Product Change Notification

Change Notification #: 113126 - 00
Change Title: Intel® Workstation System P4304CR2LFKN
PCN 113126-00, Product Design, Label
Update BIOS/ME/BMC/FRUSDR Firmware
and Labels
Date of Publication: July 14, 2014

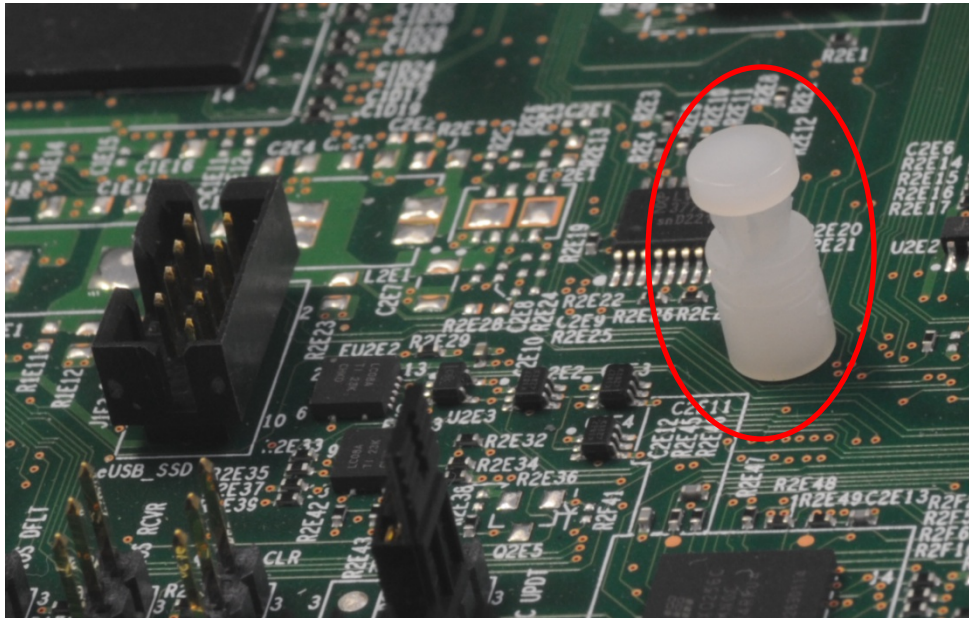
1. The Intel® Workstation Board W2600CR Printed Board Assembly (PBA) revision has been updated from G21602-302 to G21602-303 with the following changes.
 - Update the BIOS from revision 01.02.2005 to 01.03.0002.
 - Update the Manageability Engine (ME) firmware from revision 02.01.05.091 to 02.01.05.107.
 - Update the Integrated Baseboard Management Controller (BMC) firmware from revision 1.00.2812 to 1.10.3560.
 - Update the FRUSDR from revision 1.03 to 1.08.
 - Remove the plastic eUSB SSD stand-off from the system accessory kit and install it on the server board, depicted below.
